All 2015 FZ-07 models

Factory Modification Campaign - Positive Battery Cable

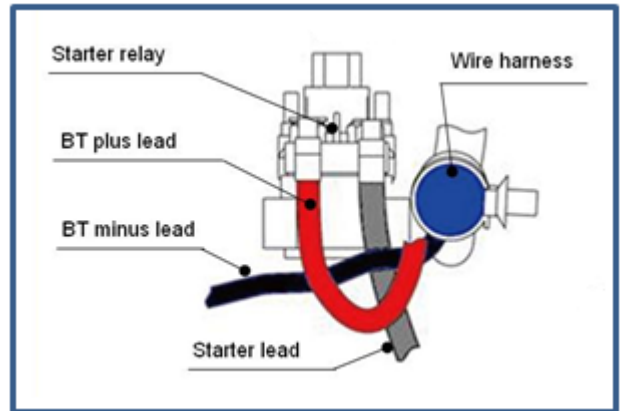
- Connect the battery positive cable to the starter relay as shown.
Tightening Torque: 2.2 Nm (0.22 m-kgf, 1.6 ft-lbf, 19.5 in-lbf)

NOTICE:
The battery cable terminal must be oriented as shown.

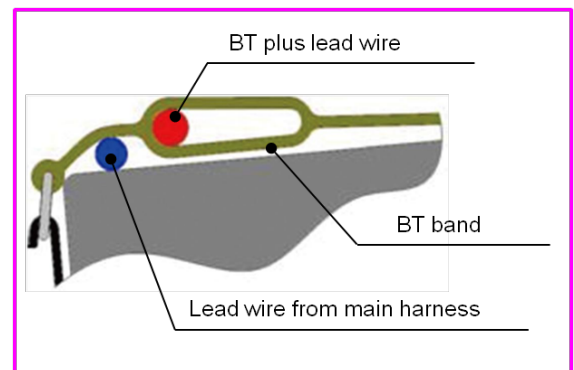
7. Route the wiring as shown in the adjacent figure.

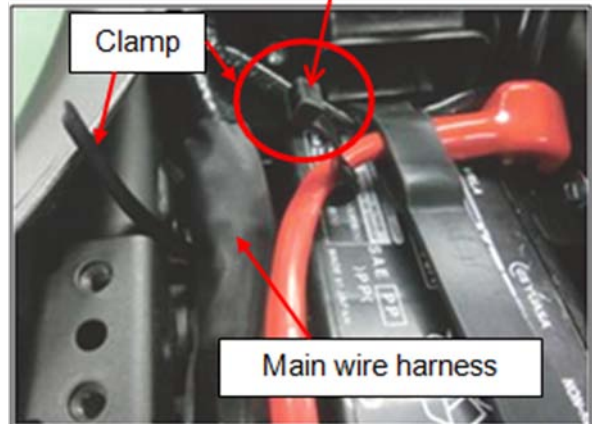
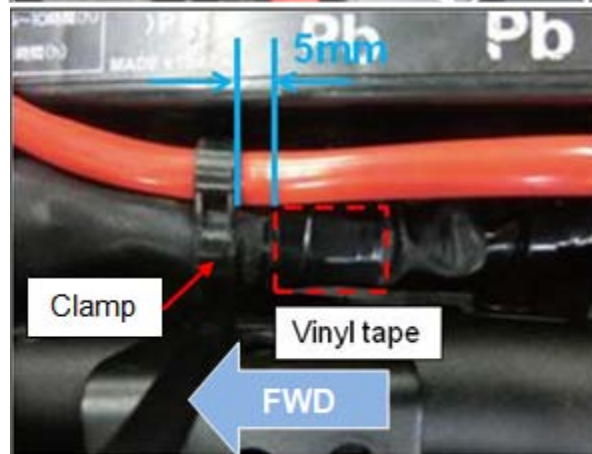
10. Install the clamp (cable tie) under the battery positive cable and the main wire harness.

The locking part of the clamp must be located as shown.

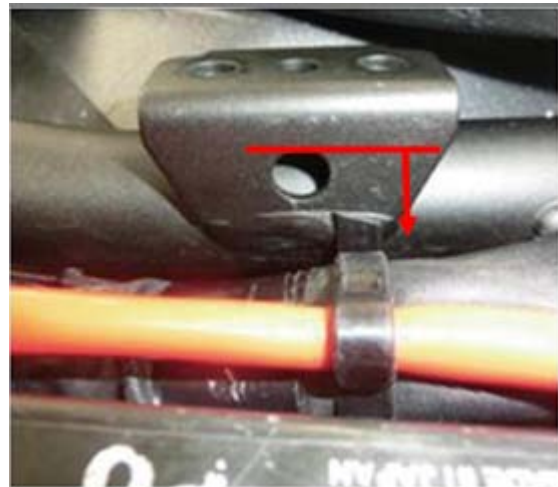
11. Fasten the battery positive cable and the main wiring harness with the clamp 5mm forward of the vinyl tape on the main wiring harness.

12. Trim excess clamp. The cutting position must be below red line in left figure.

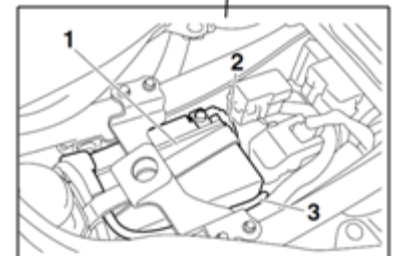
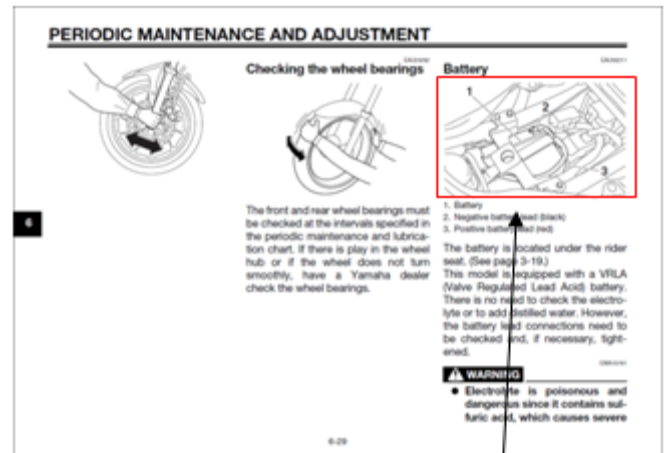
15. Put the revision sticker on page 7-30 of the Owner's Manual (LIT-11626-28-07) as shown.

Put the sticker on the battery wire routing figure.

Identification Procedure

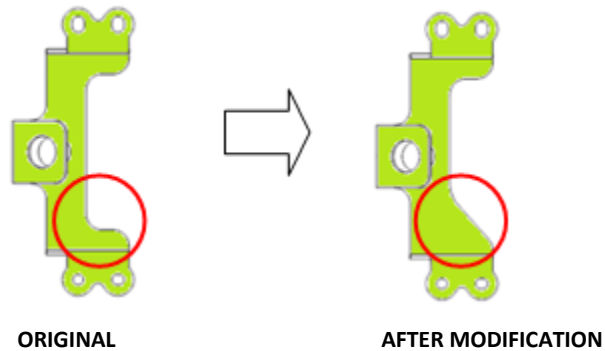
After modifying a unit, make sure to properly record and submit the warranty claim for this safety recall to update the unit's repair history in the Yamaha database. If you encounter an unfamiliar unit, check the Unit Status in YDS. A modified unit can also be identified by the shape of the seat bracket as shown below.
